INTERIM CHANGE NOTICE (ICN)

A. Document No.: PNNL-14070 **Revision No.:** 1 **Document Title:** *Groundwater Monitoring Plan for the 216-S-10 Pond and Ditch* **Document's Original Author:** BA. Williams and CJ Chou	**Implementation Date of ICN:** 11 / 1 / 06 **Change Requested By:** BA Williams

B. Action:
This ICN updates the groundwater monitoring parameter table and incorporates all new monitoring wells in the current network for the 216-S-10 Pond and Ditch.

Figure 6.1. Well Location Map at the 216-S-10 Pond and Ditch

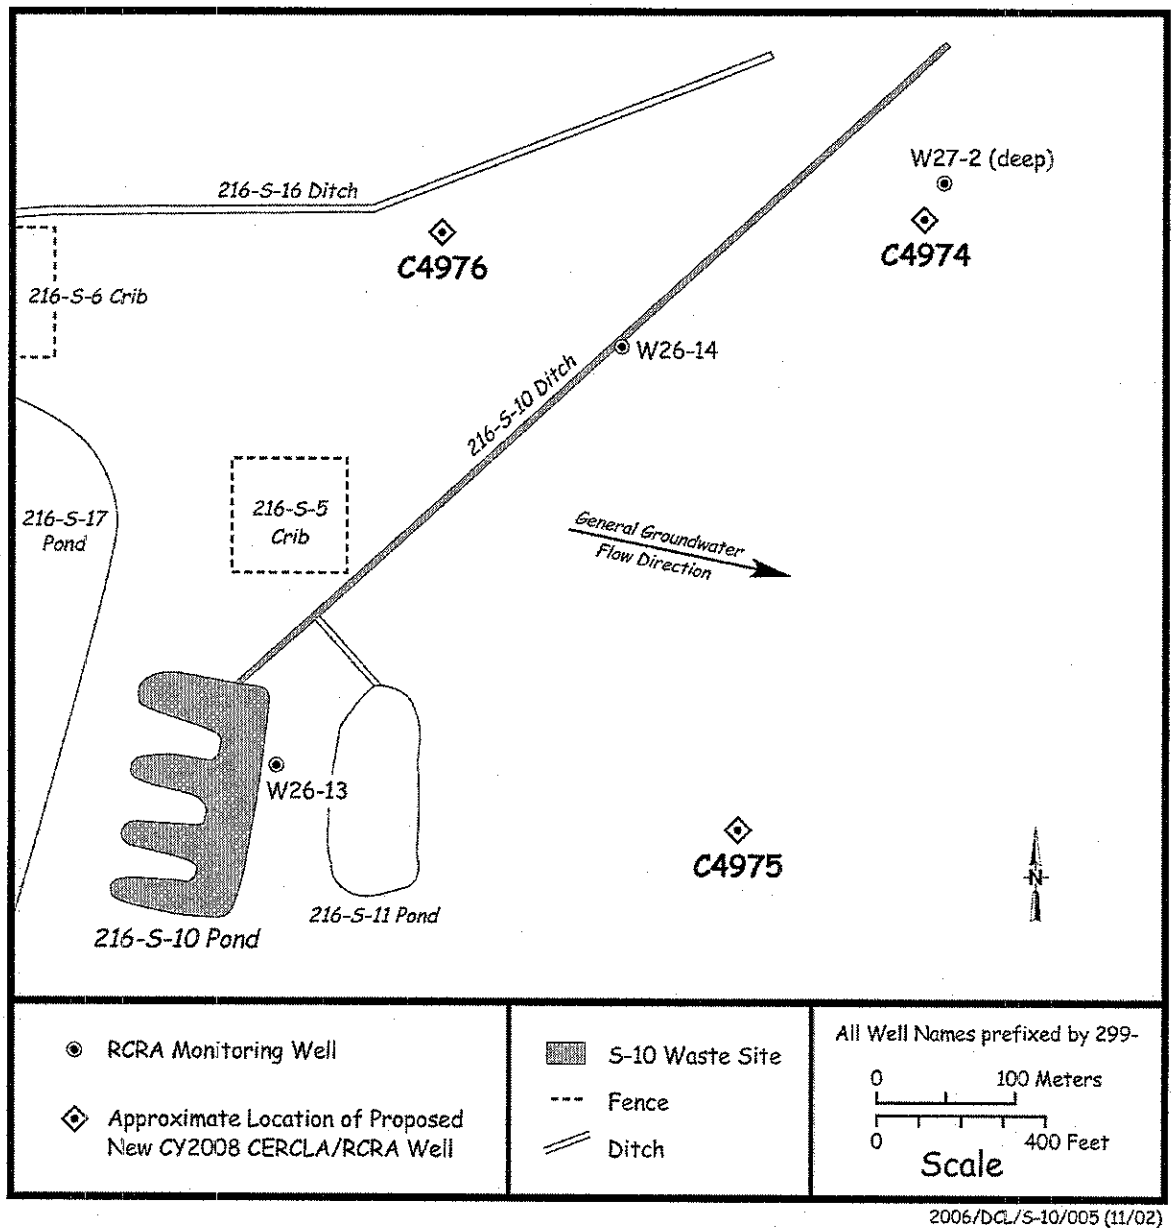
As defined in the *Post-Closure RCRA Groundwater Monitoring Plan for 216-S-10 Pond and Ditch* (PNNL- 15731) three additional wells (one upgradient, two downgradient) are currently planned (Figure1). These wells are prioritized under the Tri-Party Agreement milestone M-24-57 well drilling activities for installation in CY 2008".

Page 6.2: Replace Figure 6.1 with the new figure on attached to this ICN.

Page 6.3: Section 6.3.1, Delete first sentence of paragraph after bullets and replace with, "Figure 6.1 provides the location of the current and proposed RCRA groundwater monitoring wells for the network.
